**NOTICE OF MEETING**

May 2, 2012  
Village of Babylon Board Room  
153 West Main Street  
Babylon, NY 11702

Staff Report  
The Hamptons Club @ Eastport  
Municipality: Town of Brookhaven  
Addendum 5/2/2012  
Referral received: 4/16/12  
Jurisdiction: NYS Rte. 27, CR 111, Pine Barrens

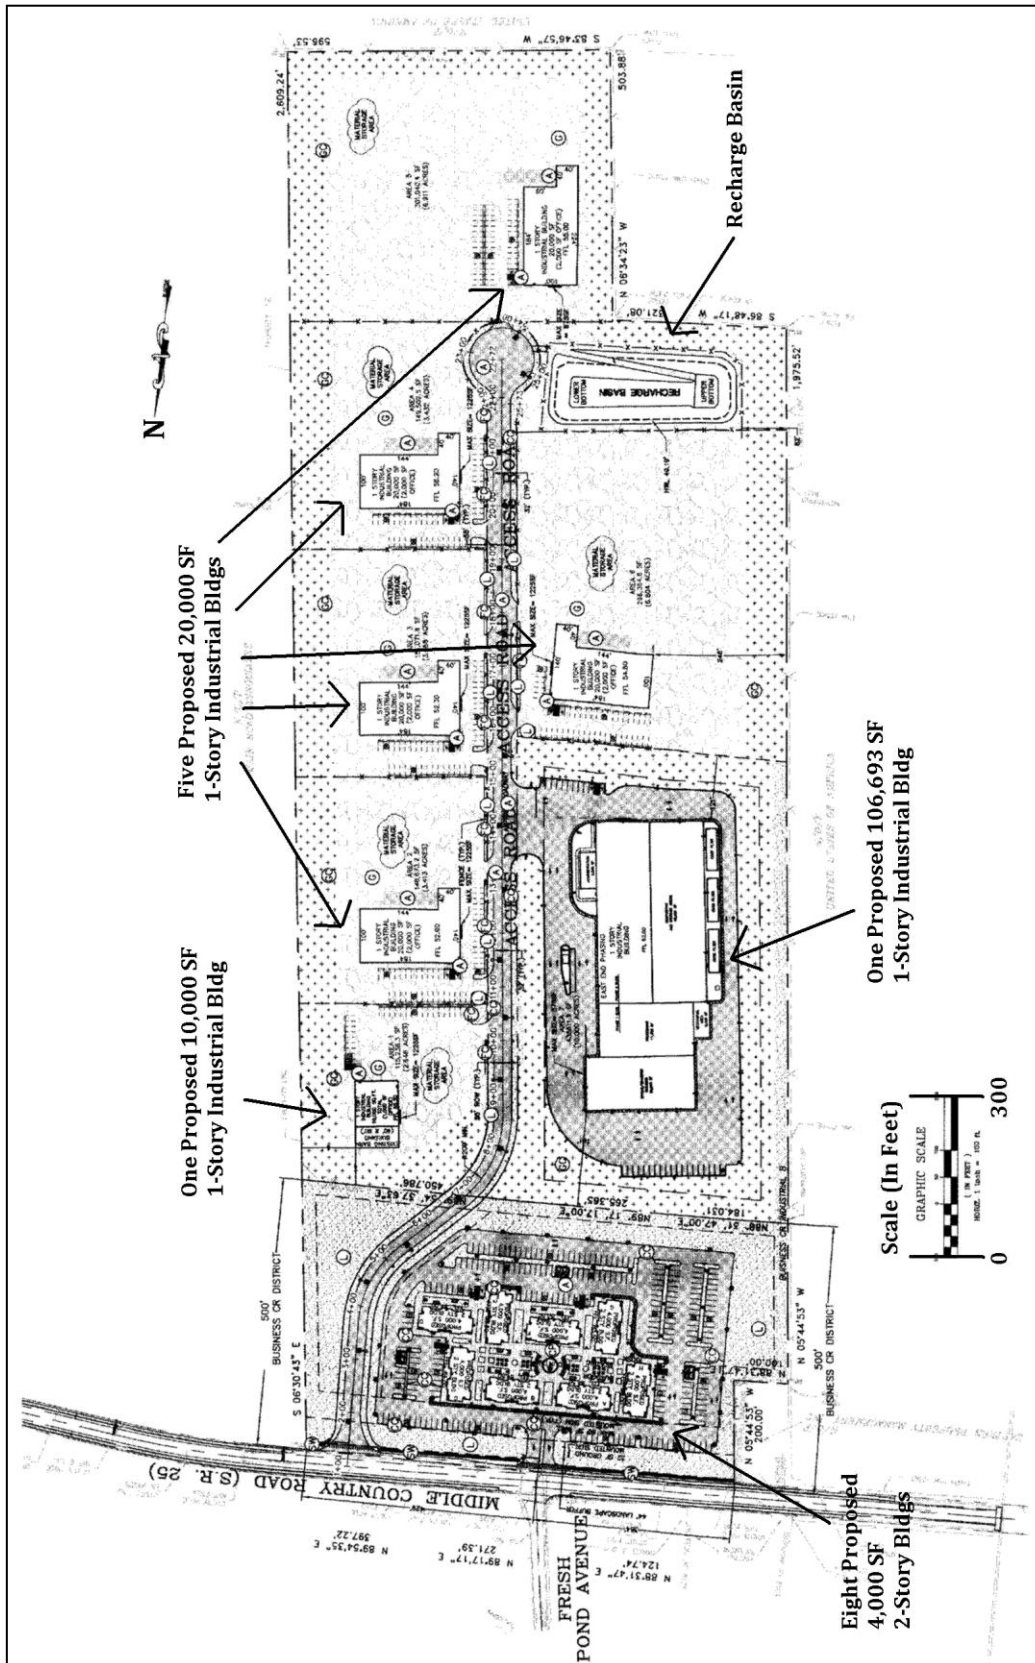
1. Applicants should contact the NYS Department of Transportation and seek all appropriate approvals.
2. The applicants should investigate with the Suffolk County DPW Transit Division, possible accommodations for bus riders particularly related to the commercial/residential component of the plan.

3. There is no emergency access proposed for either component of the site plan. An emergency access should be provided between the commercial component and the industrial component.

5. All storm water runoff should be kept on site and treated in accordance with best management practices. The applicant should be encouraged to review the Suffolk County Planning Commission publication entitled *Managing Stormwater-Natural Vegetation and Green Methodologies*.

6. The applicants should review the Suffolk County Planning Commission Guidebook particularly related to conservation of energy, public safety, and storm water management and incorporate where practical design elements recommended therein.
